Severn Tidal Power
Review of “Interim Options
Analysis Report”

5079276/RPT/02

Review of “Interim Options Analysis Report”

prepared for a consortium of NGOs including the WWF, WWT, National Trust, RSPB and the Wye and Usk Foundation

Figure 3.2. Annual-average power (GW) v. fraction of original tidal range seen across barrage. Curves are for Taylor’s sites A-E in Figure 3.1

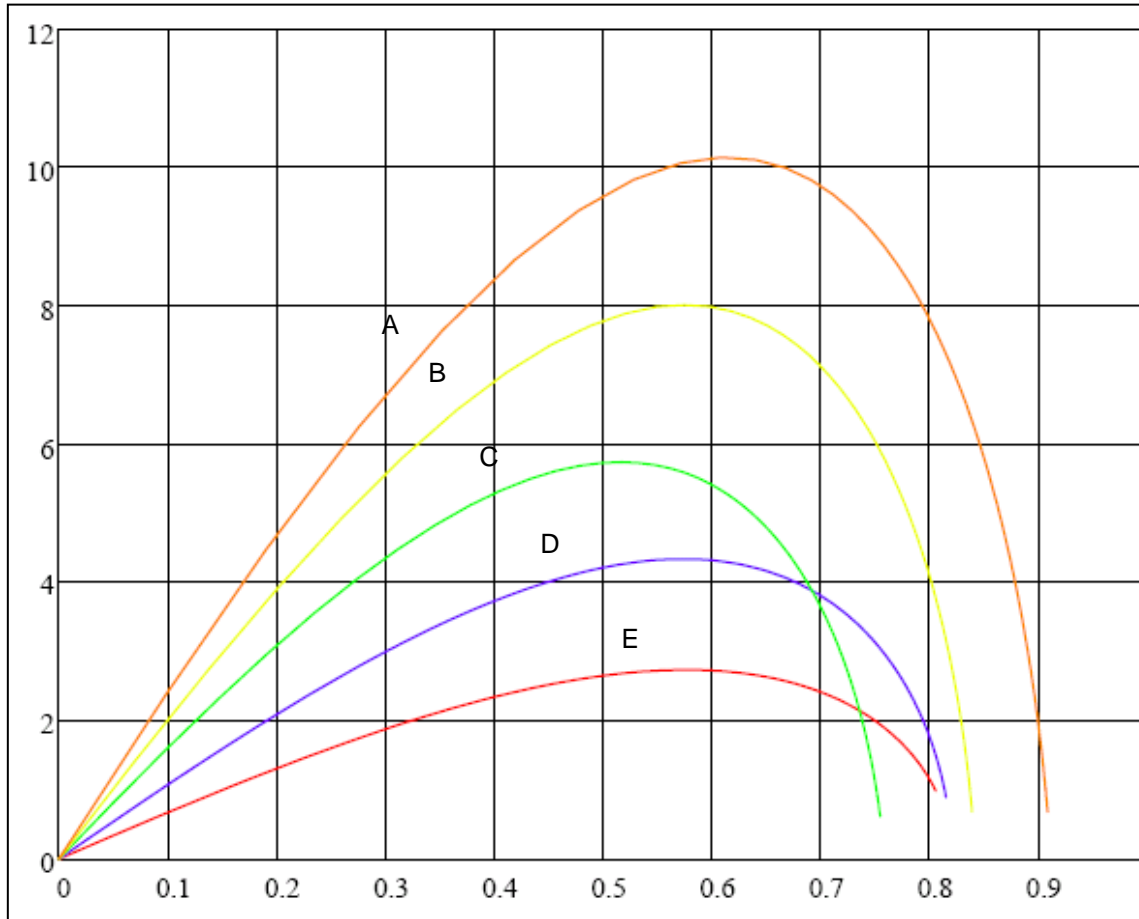
From Figure 3.2, the annual-average power available at Taylor’s site E, which is close to the Cardiff-Weston barrage, is 2.7 GW. Assuming an overall conversion efficiency of 75% (see next Section – this figure relies on very large turbines), this is $2.7 \times 24 \times 365 \times 0.75 = 18$ TWh/yr, which is slightly in excess of the figure of 17 TWh/yr quoted in the IOAR (Vol 1, Table ES1) for a barrage with ebb-only generation. This is consistent with the conventional view, cited in Section 3.1, that two-way generation gives more power, if turbine efficiency can be maintained.

By contrast, however, the IOAR gives (Vol 1 p.29) a figure of only 13 TWh/yr for the tidal reef scheme. This is much less than the figure from Figure 3.2 for this site, which is approximately 4.7 GW (it is approximately 25% of the way between Taylor’s sections D and C). Assuming an overall conversion efficiency of 75% (see next Section), this is $4.7 \times 24 \times 365 \times 0.75 = 31$ TWh/yr. The IOAR figure of 13 TWh/yr is also much less than the figure given in the IOAR for an ebb-only barrage at this site, which is 25 TWh/yr (see Section 3.1). The IOAR appears (Vol 1 p.28) to be making some very sub-optimal assumptions about the operation of the Tidal Reef, which gives the misleading impression that two-way generation necessarily gives less power than ebb-only generation.

Figure 3.3. Maximum powers from Figure 3.2, plotted against reservoir area

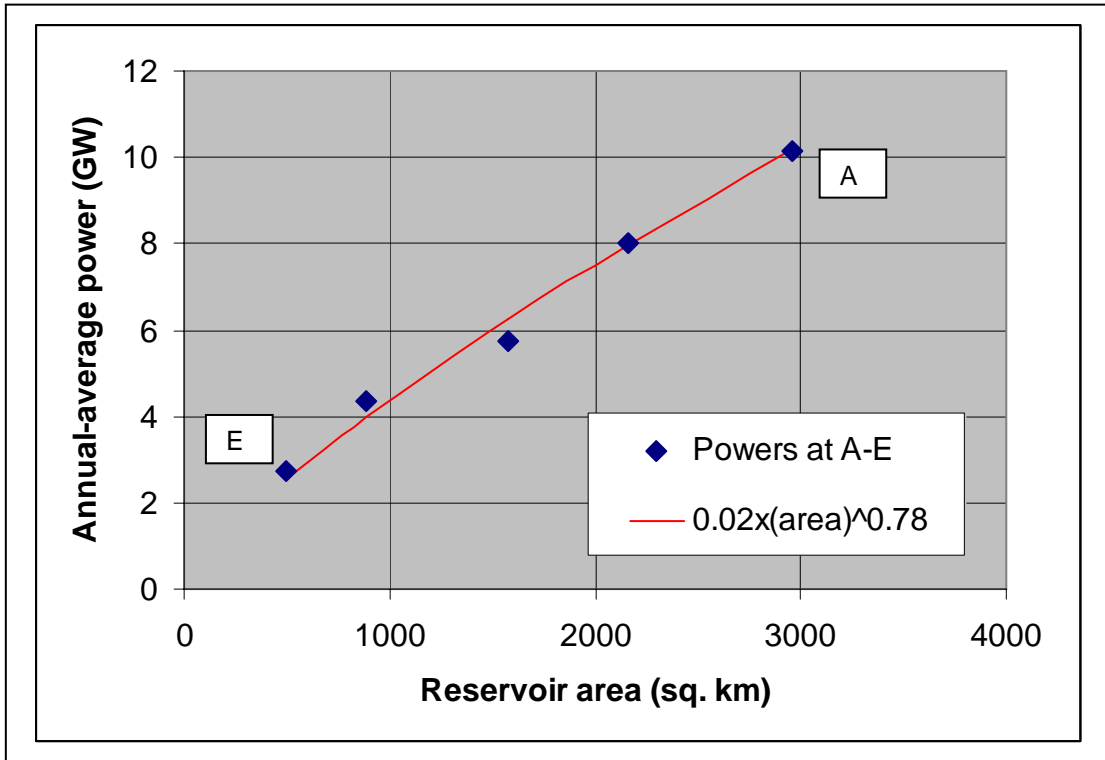
In the style of Fig. 4.1 in Vol 1 of the IOAR, an empirical relationship may be fitted to the data – the power is evidently proportional to:

This is in reasonable agreement with the relationship proposed in the IAOR (see Section 3.1 above), given that it is based on a different part of the estuary.

Figure 4.3. Cross-section of caisson with scaled-up MJ2 turbine, mounted for two-way operation

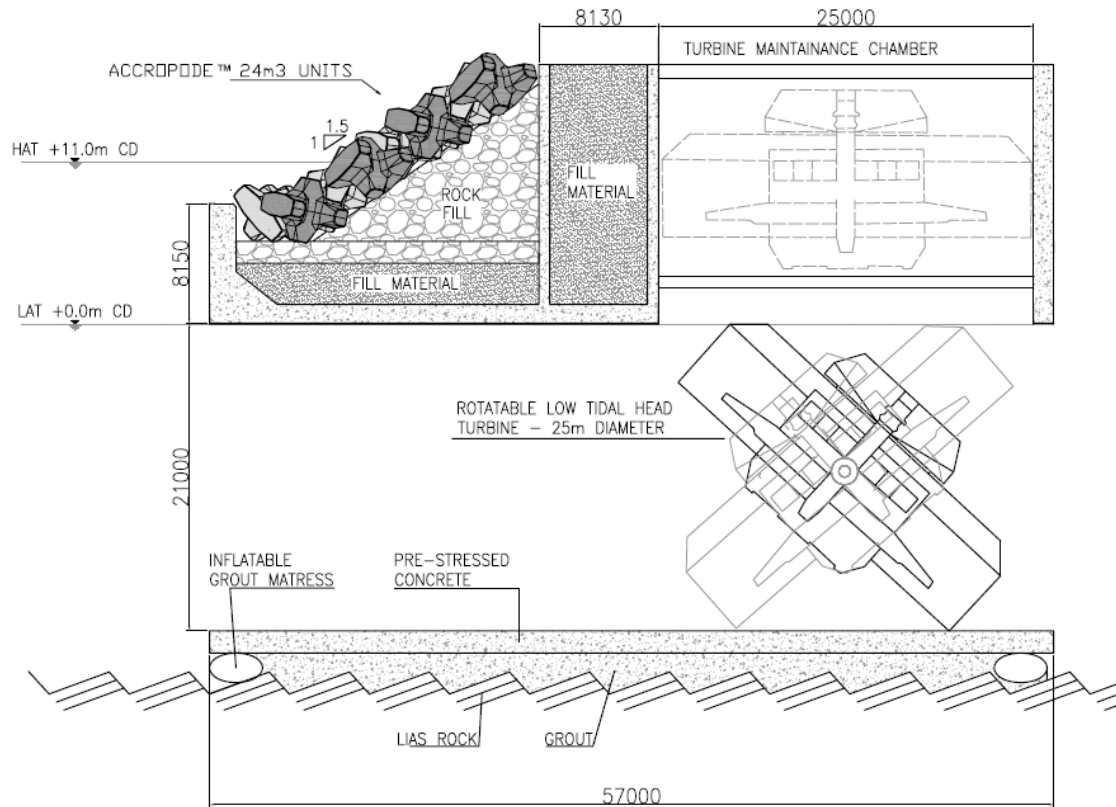
The MJ2 turbine is easily made bi-directional, by rocking its frame (already on bearings) to allow retraction for maintenance, see Figures 4.1 and 4.2) like a see-saw, see Figure 4.3 below (based on the caisson design proposed in Ref [2]).

In our earlier Report (Ref. [2]), the overall efficiency is given as 75% (i.e. 90% each from turbine efficiency, kinetic energy losses and power take-off efficiency, giving $(90\%)^3 = 75\%$ overall). From the estimated annual-average absorbed power of 4.7 GW at the Minehead-Aberthaw site, given in the previous Section, this gives an annual-average power of $4.7 \times 0.75 = 3.5$ GW. The peak power during an average power cycle will therefore be $2 \times 3.5 = 7$ GW. A Minehead-Aberthaw barrier would be approximately 20 km long, giving space for 700 turbines, so the peak power of a single turbine in an average power cycle is $7,000\text{MW}/700 = 10$ MW.

Figure 5.1: Caisson Construction Port Facility

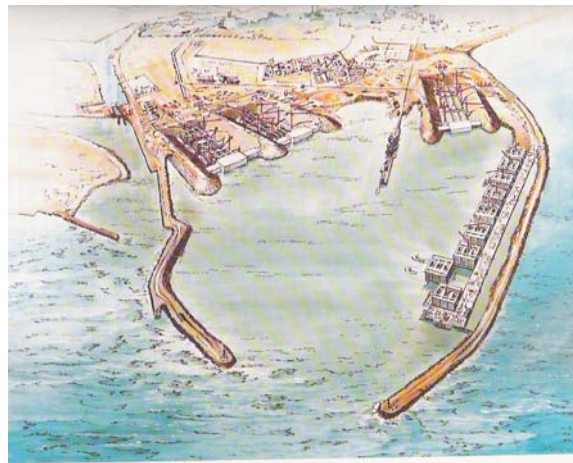
The required draft for floating a caisson = 20.5 (trimmed draft) + 2.1 under keel clearance = 22.6m draft requirement. Port Talbot dock has a stated draft of 20.84m at MHWS at the Dock entrance. This means that caissons will only be able to float out on spring tides higher than the mean, or that some dredging will be required. These problems are not insurmountable, but do demonstrate a lack of any detailed planning behind the cost estimates.

Regardless of the use of Port Talbot, a second facility will be required on the Severn. The Ports of Barry, Cardiff, and Avonmouth are all restricted by the size of lock gates and various draft restrictions and could probably not accommodate the size of caissons required.
